To: Members of Dublin City Council
From: Dana L. McDaniel, City Manager 
Date: August 24, 2017
Initiated By: Vincent A. Papsidero, FAICP, Planning Director
Terry D. Foegler, Director of Strategic Initiatives
Jennifer M. Rauch, AICP, Planning Manager
Re: Resolution 64-17 - Grounds of Remembrance - Landscape Plan

GROUNDS OF REMEMBRANCE

LANDSCAPE PLAN

Dublin Grounds of Remembrance - Proposed Landscape Plan

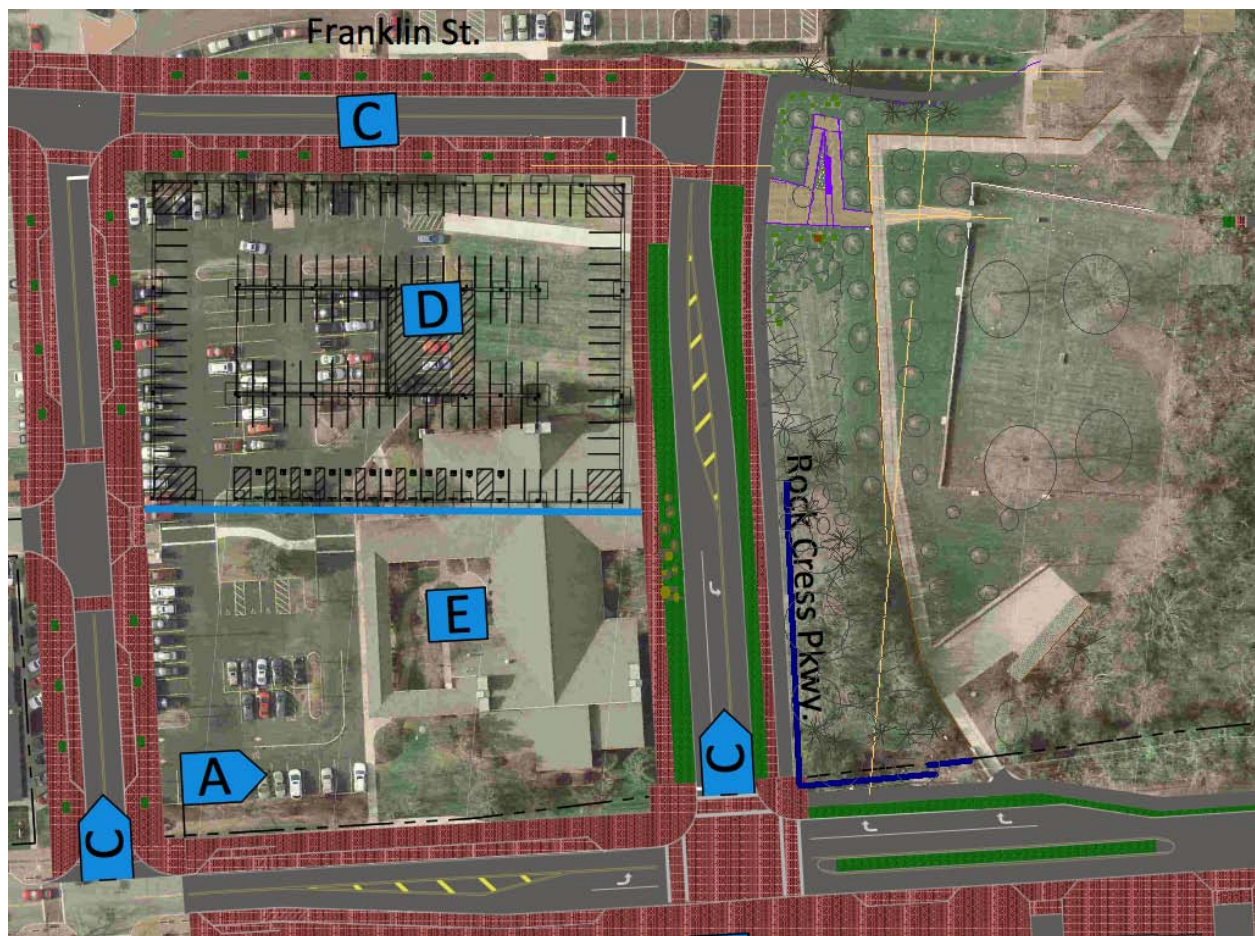
I've included a rough sketch showing a switchback and steps (with Sycamores) that makes a stronger entry, but in my mind, doesn't compete with the Memorial. Perhaps this provides a setting for seating, bike racks, flowers, a flag, or even a more traditional bronze Revolutionary soldier sculpture (five are buried in the cemetery).

I used alignments cues from both the Memorial alignments and the cemetery walls; but maybe an entrance/approach plaza might also respond to a straightforward axial layout with the cemetery entrance and the Memorial railing break.
